# AURIX™ TC33x/TC32x errata sheet

Marking/Step: (E)ES-AA, AA

## About this document

**Figure 1** Message buffer transfer from Message RAM to OBF

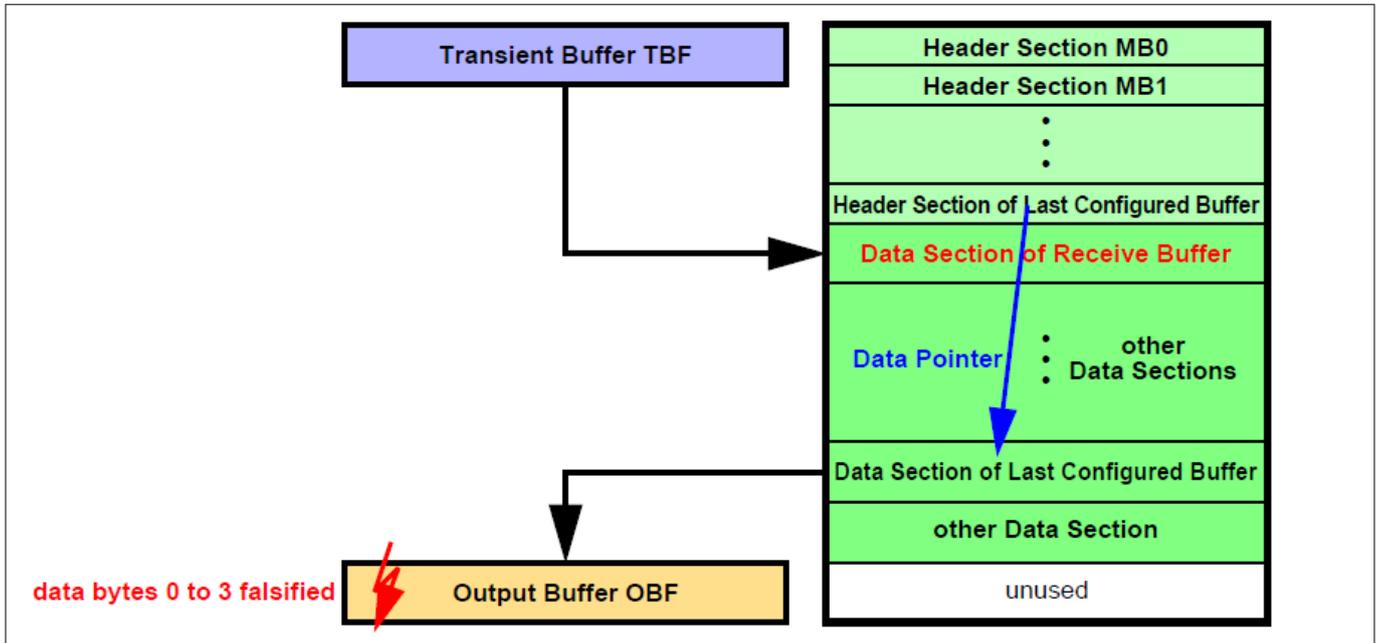
When the message buffer has its payload configured to maximum length (`PLC = 127`), the OBF word on address `00h` (payload data bytes 0 to 3) is overwritten with unexpected data at the end of the transfer.

**Figure 2** Message buffer transfer from IBF to Message RAM

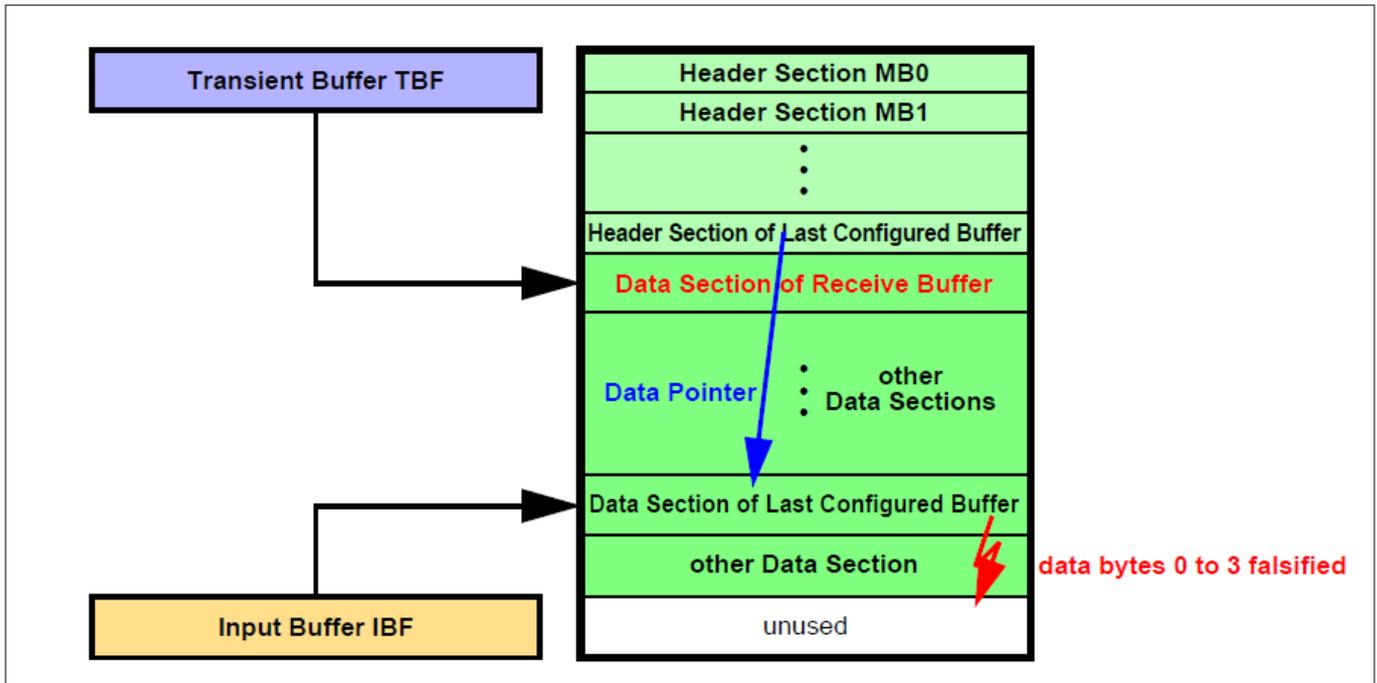
After the Data Section of the selected message buffer in the Message RAM has been written, one additional write access overwrites the following word in the Message RAM which might be the first word of the next Data Section.

- a) When a message is transferred from the Last Configured Buffer in the Message RAM to the OBF and PLC = 127 it may happen, that at the end of the transfer the OBF word on address 00h (payload data bytes 0 to 3) is overwritten with unexpected data (see [Figure 1](#))
- b) When a message is transferred from IBF to the Last Configured Buffer in the Message RAM, it may happen, that at the end of the transfer of the Data Section one additional write access overwrites the following word, which may be the first word of another message's Data Section in the Message RAM (see [Figure 2](#))

**Figure 3** Message RAM configurations

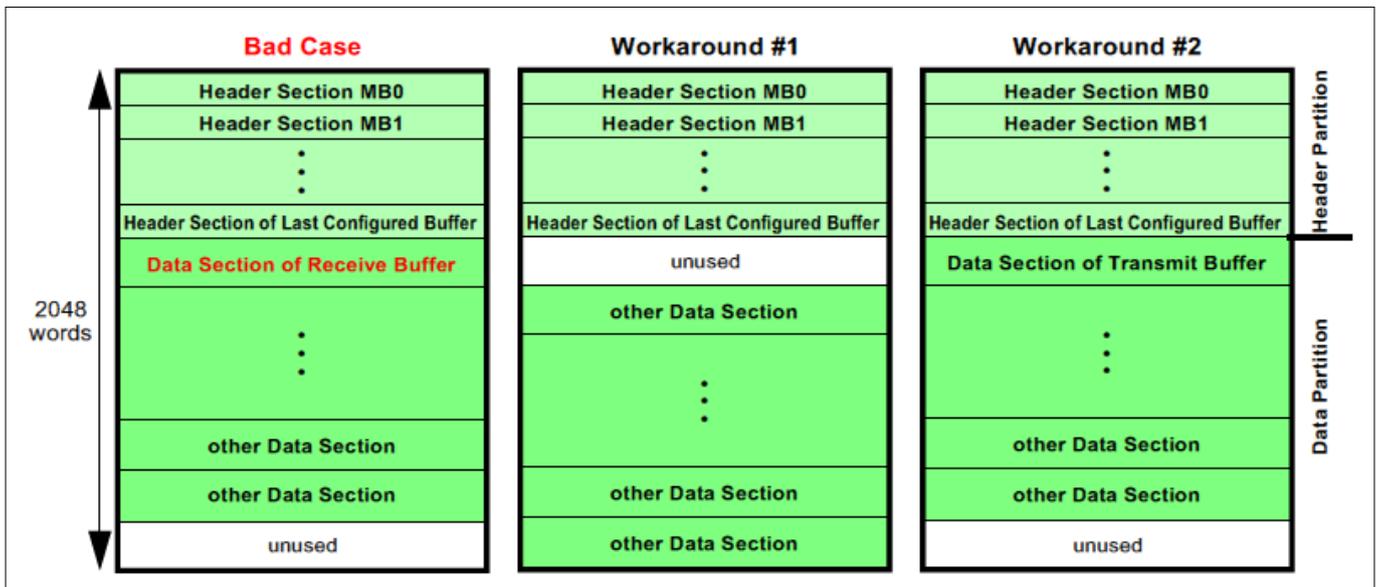
The erratum is limited to the case when (see Figure 3 “Bad Case”):

**Workaround 2**

Ensure that the Data Section directly following the Header Partition is assigned to a transmit buffer.

Figure 7 Package Outlines TQFP-144 for TC33x/TC32x

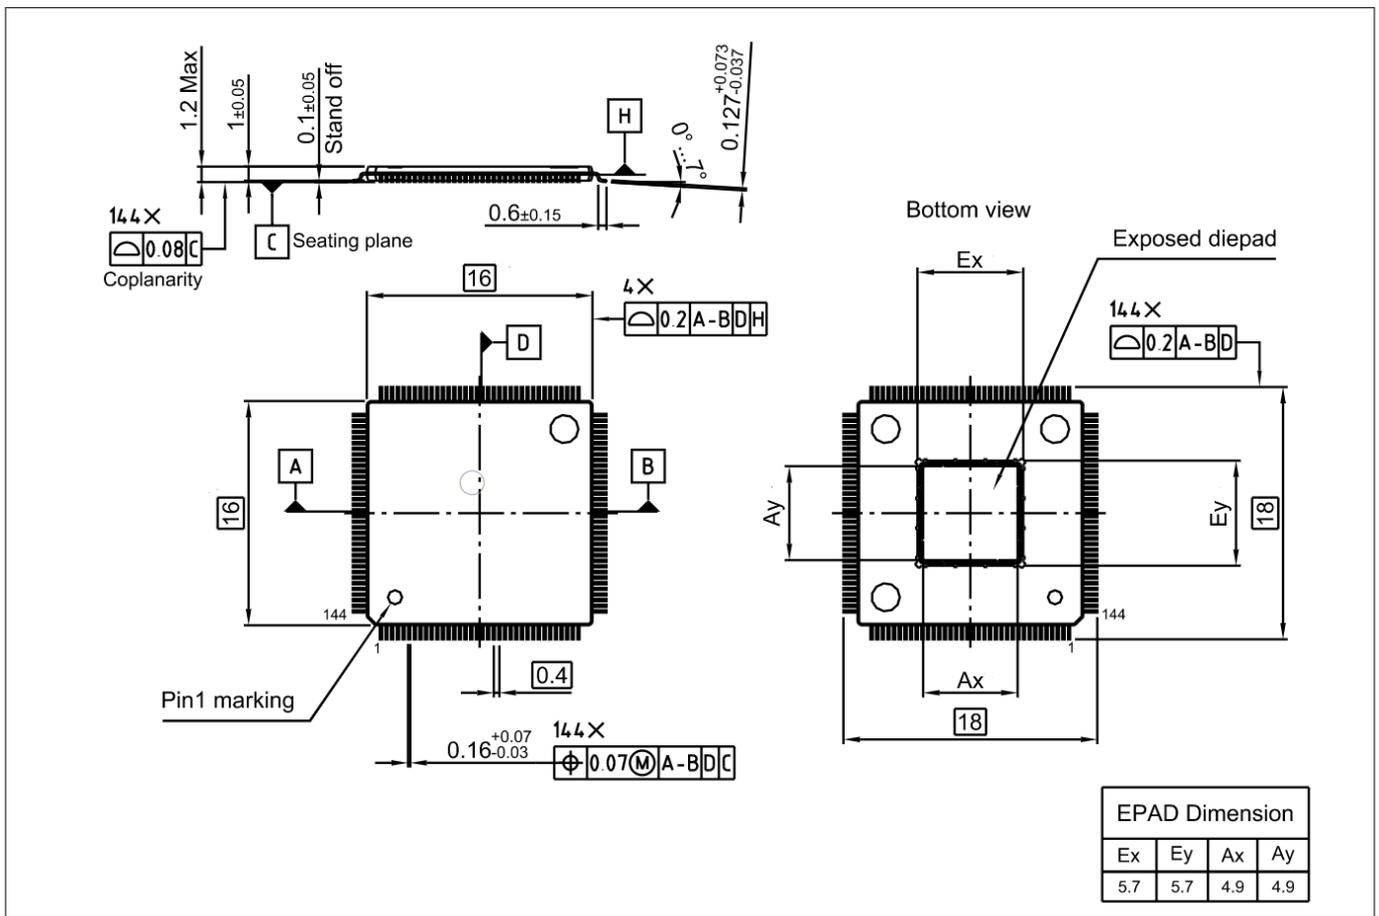
Furthermore, for the exposed die pads, the maximum boundary of the structural corner protrusions to be considered during system design and integration has been added.

**Note:** For the exposed diepad of the TQFP-144 package of the TC33x/TC32x, structural corner protrusions have to be considered for purposes of system design and integration with a maximum boundary of 6.2 mm.

This information shall substitute the corresponding information in the TC33x/TC32x AA-step Data Sheet V1.1.

**Figure 8 Package Outlines TQFP-100 for TC33x/TC32x**

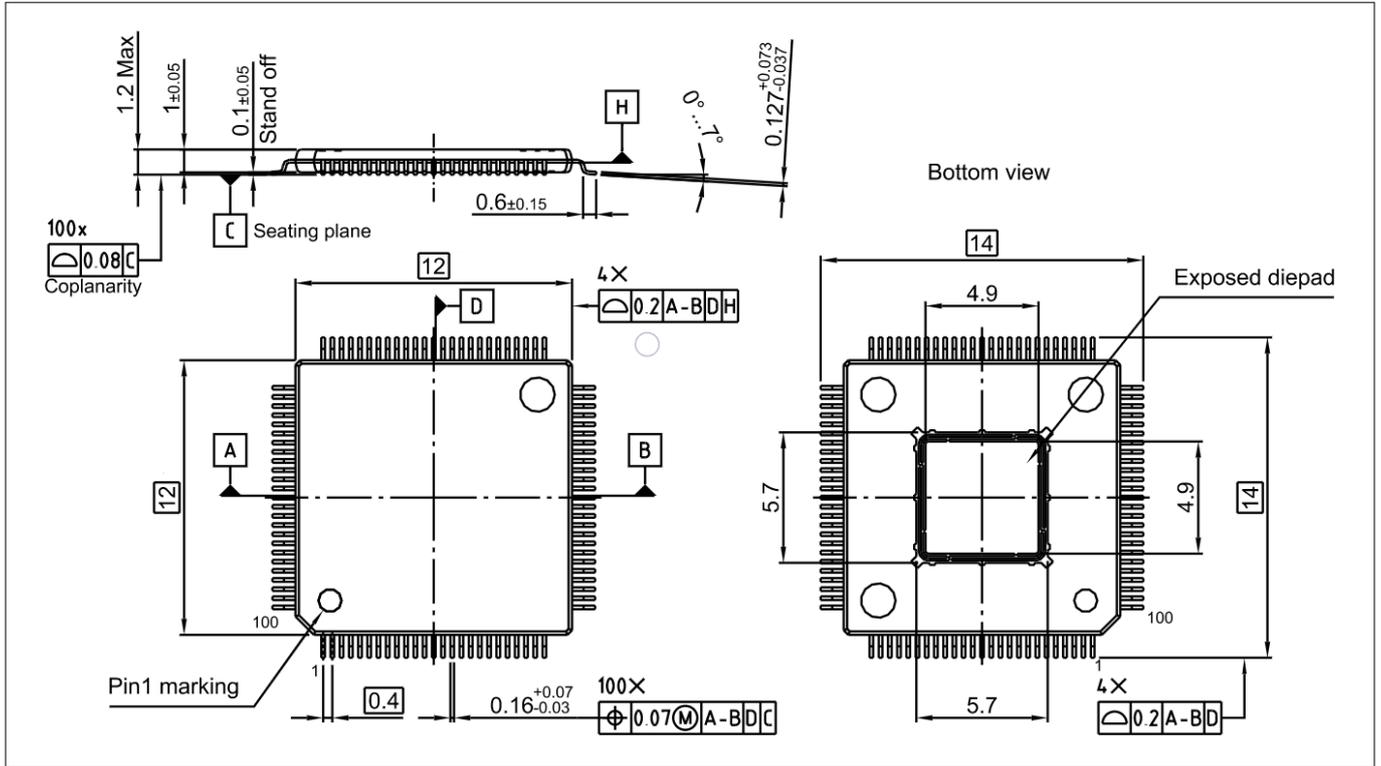
**Note:** For the exposed diepad of the TQFP-100 package of the TC33x/TC32x, structural corner protrusions have to be considered for purposes of system design and integration with a maximum boundary of 6.3 mm.

**Figure 10 VCAP behavior during start-up when EVRC regulator is used - corrected**

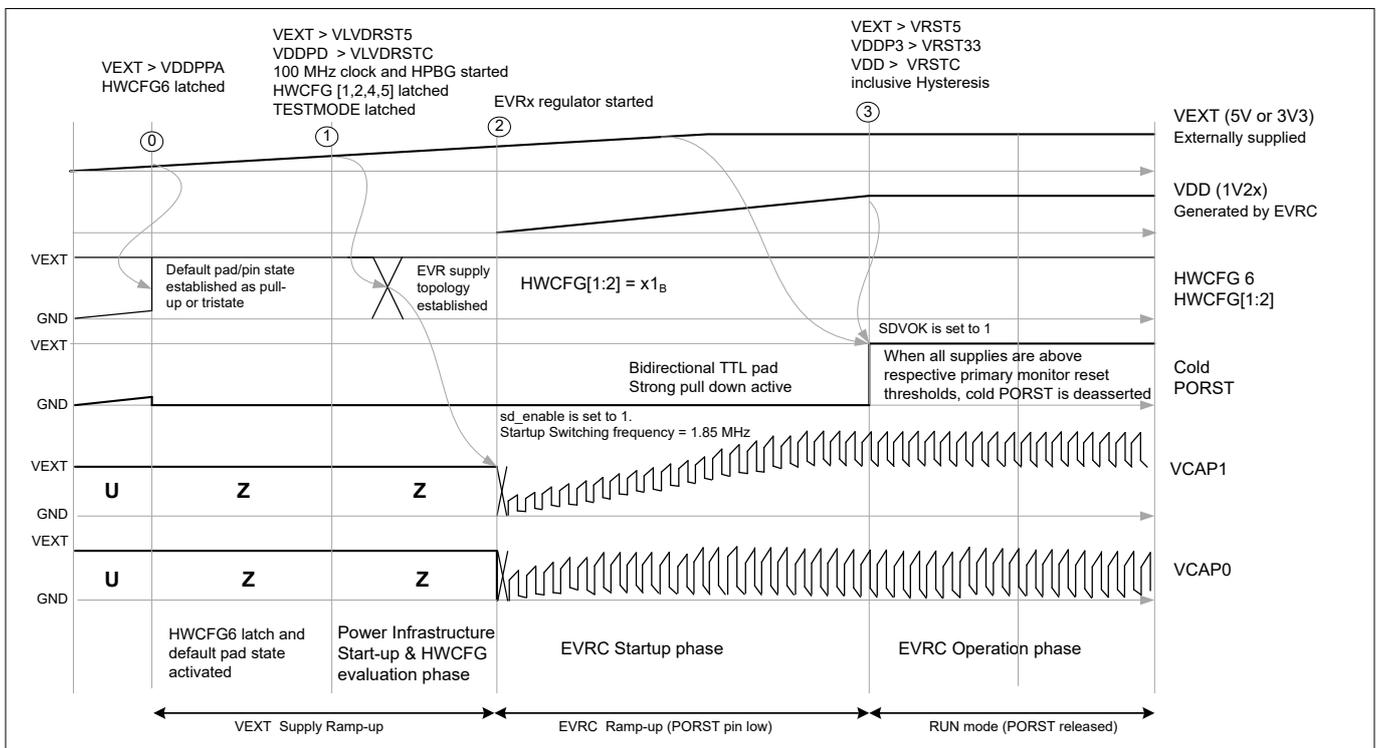
See corrected figures included below.
